DEVIATION REQUEST (Attach diagrams, figures, and other documentation to clarify request)

Section 2.3.2 Design Standards by Functional Classification: Minimum Centerline Curve Radius for Major Collector, as shown in Table 2-5. Roadway Design Standards for Rural Collectors and Locals.

TANJA CURTIS - SUBDIVISION

EXISTING AND PROPOSED
SUBDIVISION MAP - 5 LOTS
WITH 711' RADIUS FOR
MINOR COLLECTOR W/ 60'
ROW

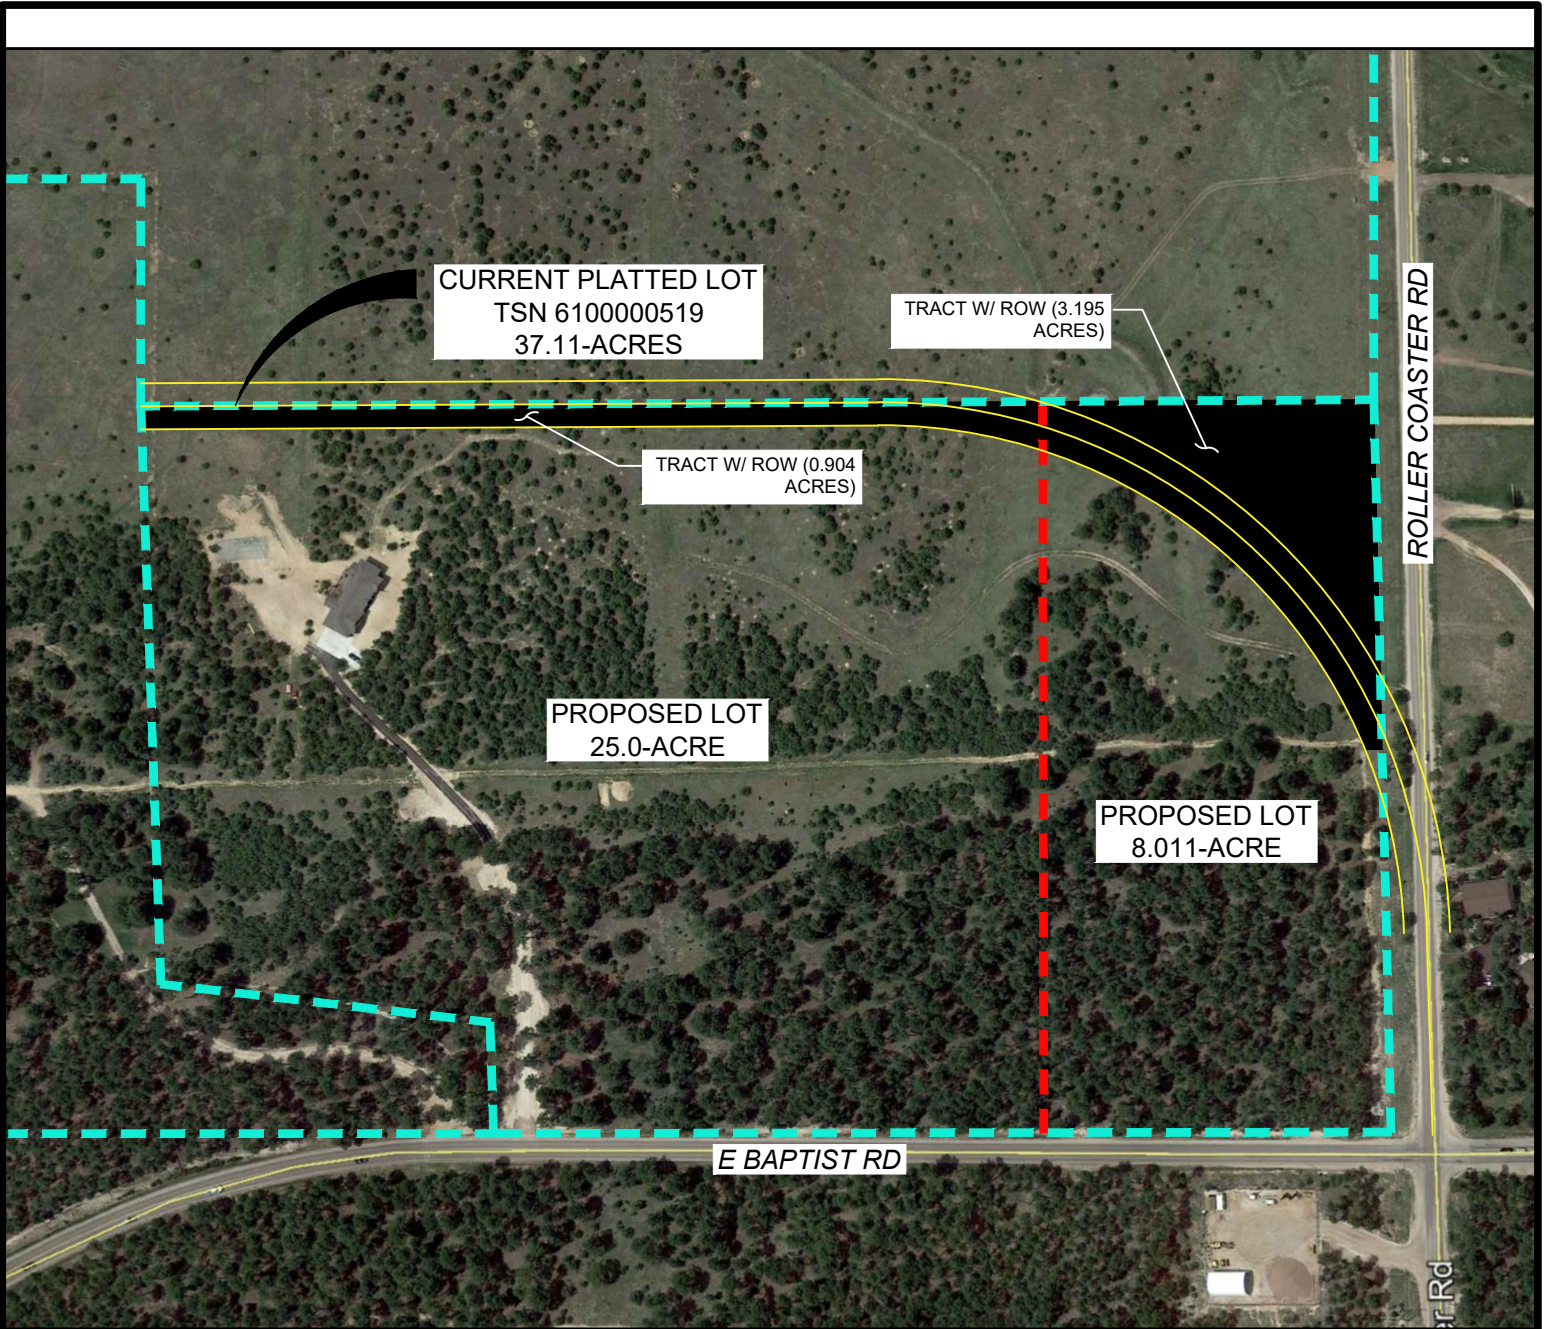
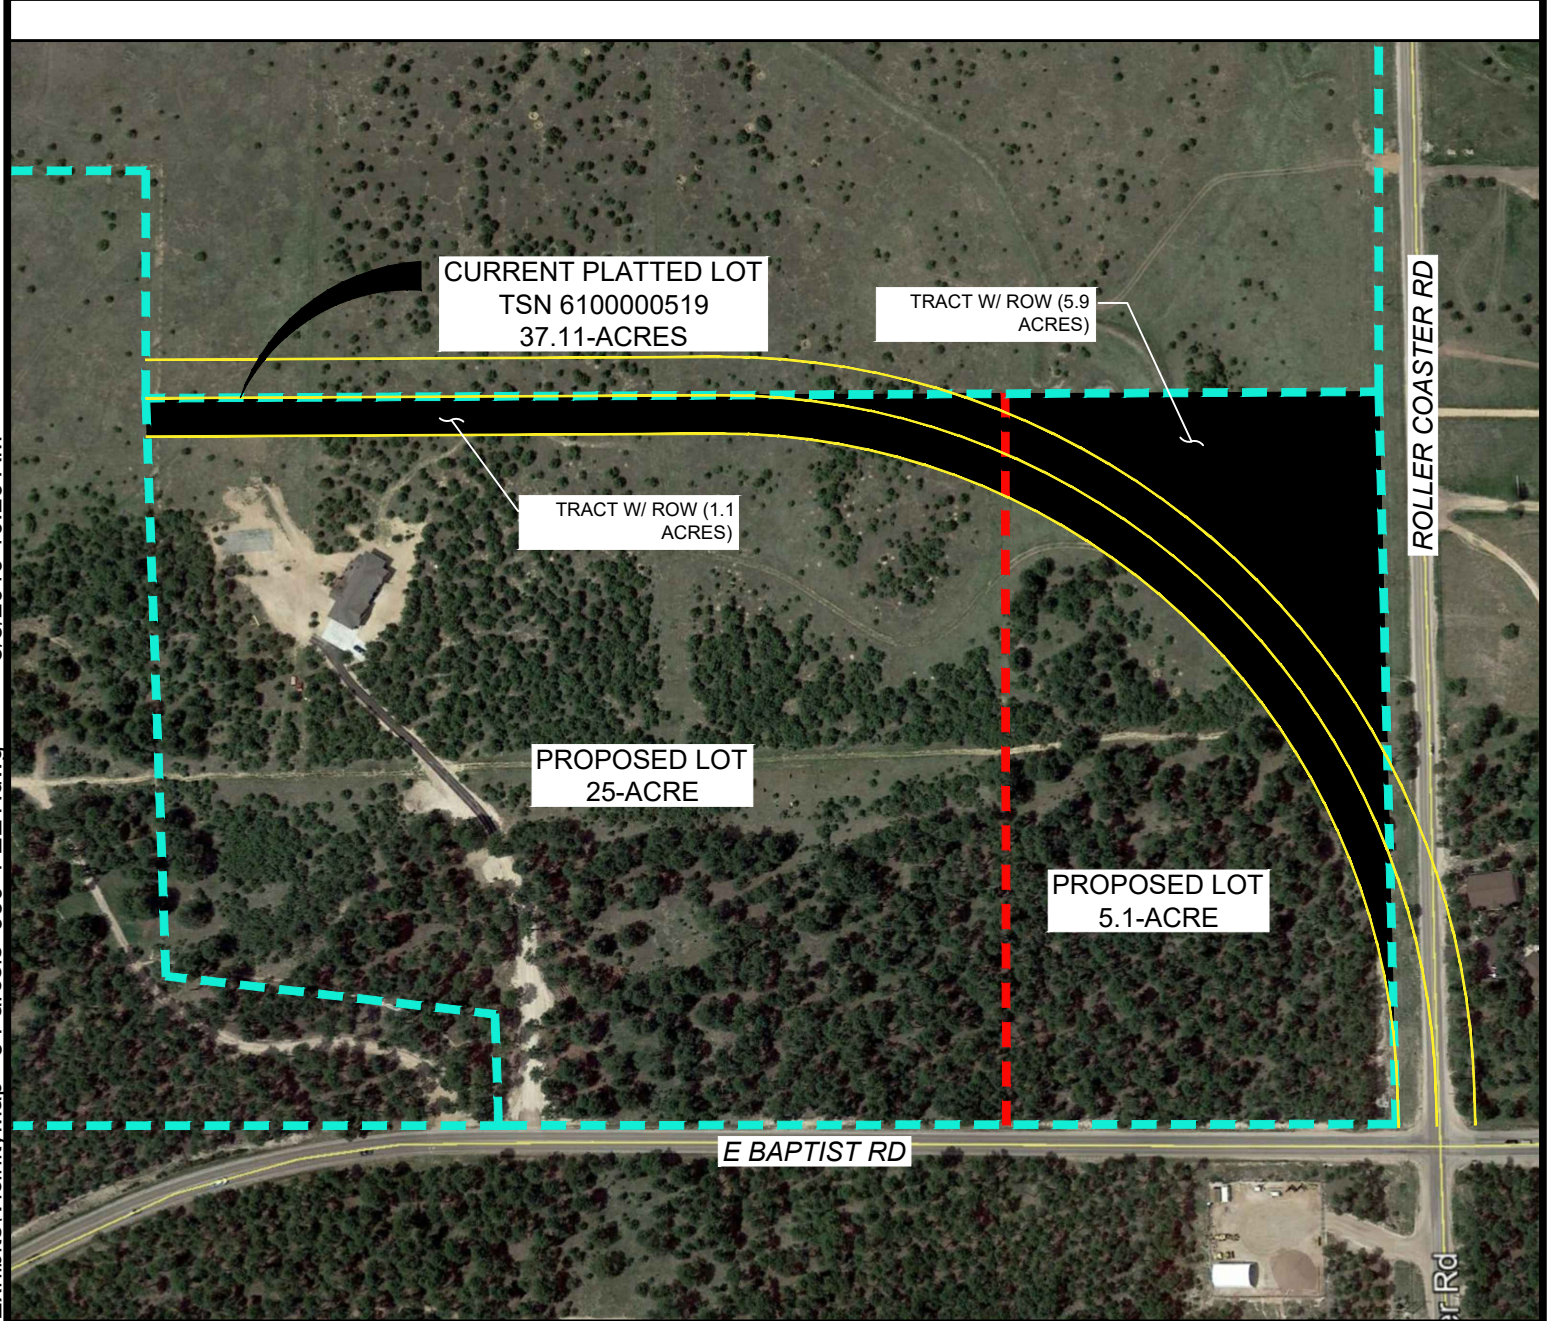
A deviation is proposed for the posted speed limit for the anticipated, future roadway. ECM standard is a 50mph design speed and 930-foot centerline radius. The proposed deviation is for a 45mph design speed and 711-foot centerline radius.

The request is for a reduction in the design speed of the roadway from 50mph to 45mph. This would, in turn, reduce the required minimum centerline curve radius from 930-feet to 711-feet per AASHTO standards. With this, the Owner of the property will not have to sacrifice an excessive portion of their property and the County will still be granted enough land for an adequate roadway from Roller Coaster Road.

This request has been determined to have met the criteria for approval. A deviation from Section 2.3.2 of the ECM is hereby granted based on the justification provided.
